BBTB Date:	24 Jan 2024
BBTB Number:	BBTB-110
BBTB Title:	CARE2 Background Noise Issue
System Description:	CARE2 Networked Systems
Product(s) Affected:	C2CB4 / C2CS4 / C2NEP
Reference:	PRCR3043
Priority:	3

DESCRIPTION OF THE PROBLEM

Figure 3 — Fit capacitor between 0V and GND on C2CN

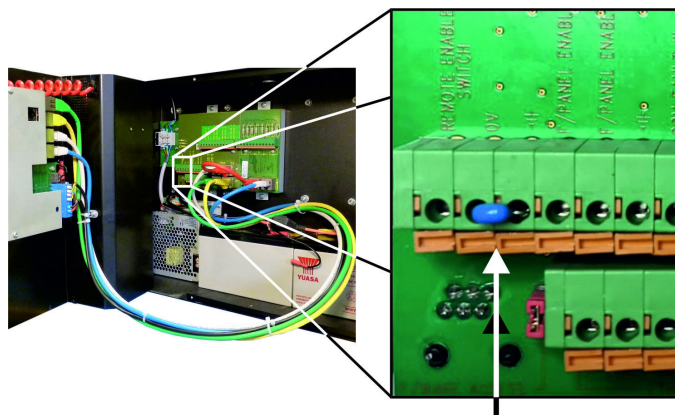
Baldwin Boxall has identified a potential issue with some CARE2 systems where there is an increased level of background noise heard in the handset on networked installations.

Affected CARE2 installations may experience a higher than normal “50Hz” hum, audible in the handset in the background of all calls.

3. Using a suitable tool, push the orange spring clamps down and fit capacitor between 0V and GND on C2CN as shown in Figure 3. Release the clamps once the capacitor is fitted.

Fit capacitor between "0V" and "GND"
on the C2CN Network Card

Baldwin Boxall can provide, free of charge, a component that can be easily be fitted to the C2CN module that will reduce the background noise level.
